MIL-PRF-39035C
AMENDMENT 3
22 July 1997
SUPERSEDING
AMENDMENT 2
31 January 1994

RESISTOR, VARIABLE, NON-WIRE-WOUND (ADJUSTMENT TYPE),
ESTABLISHED RELIABILITY
GENERAL SPECIFICATION FOR

This amendment forms a part of MIL-PRF-39035C, dated 11 October 1991, and is approved for use by all Departments and Agencies of the Department of Defense.

FIGURE 2. Derating curve for high ambient temperatures. "

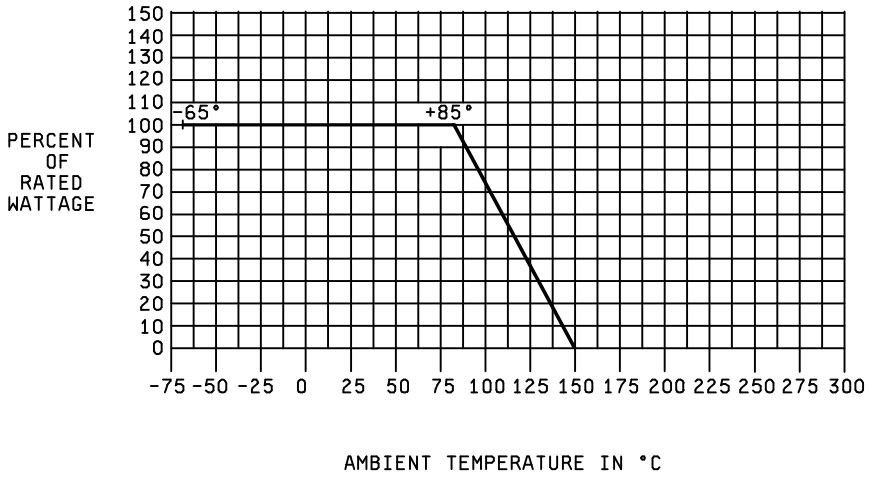
FIGURE 2, delete and substitute:
